8560EC-04

S E R V I C E N O T E

856xEC Series Portable Spectrum Analyzer

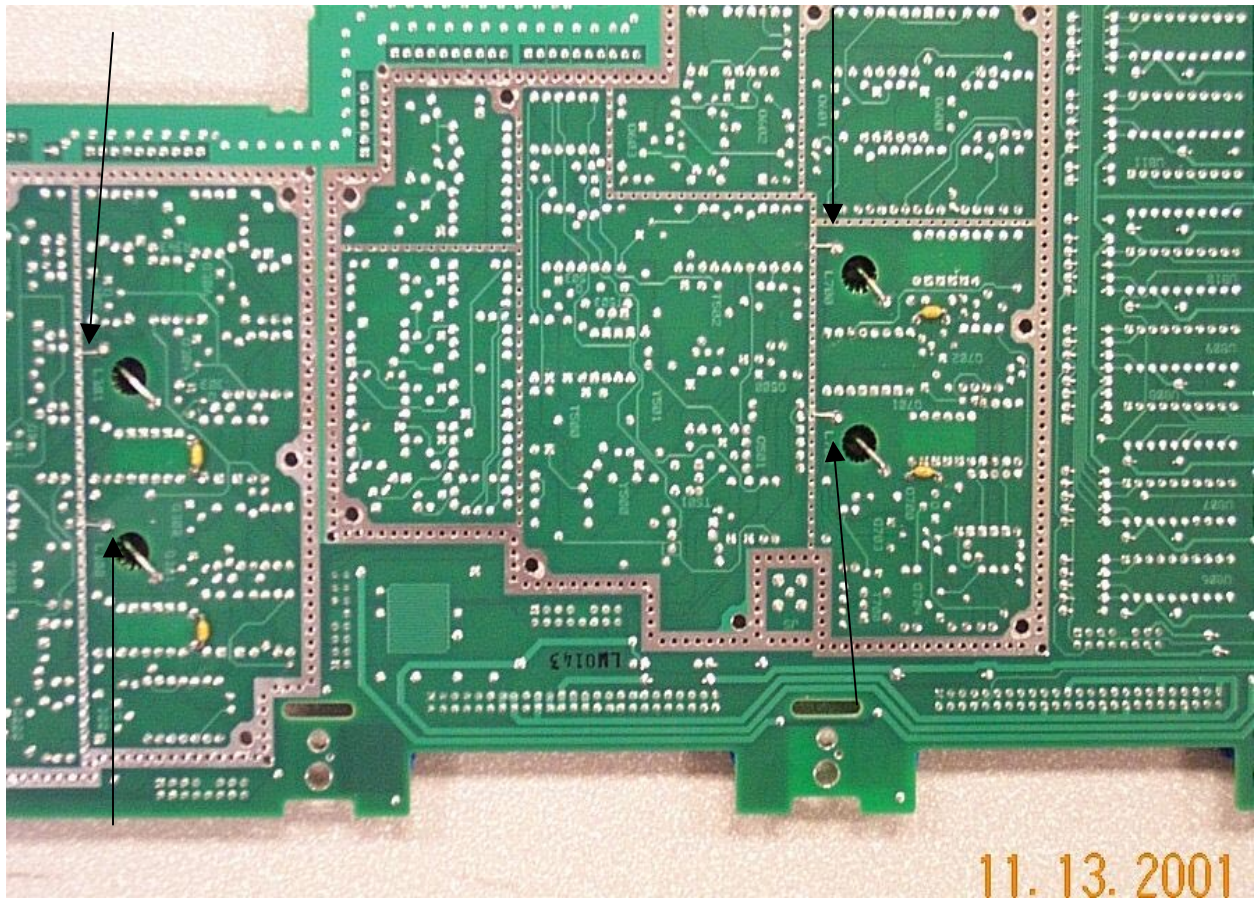
For the instruments specified above, inductors within the A5 IF assembly are not making good connections to ground thereby giving error messages related to the A4 Log Amp board. Error numbers that appear in the lower right-hand corner of the screen on account of this problem are errors 561, 562, and 565.

If the serial number of the instrument applies to the ones above, the following butch may solve the problem. Remove the shielding from the A5 IF assembly. Locate the inductors, and according to the attached photograph, insert and solder one end of the 8150-4222 wire into the hole connecting to the inductors and solder the other end to the ground plane on the front layer of the board. Do this for each inductor. See attached picture, the arrows point to where the jumpers are attached.

Add jumpers according to the picture above.
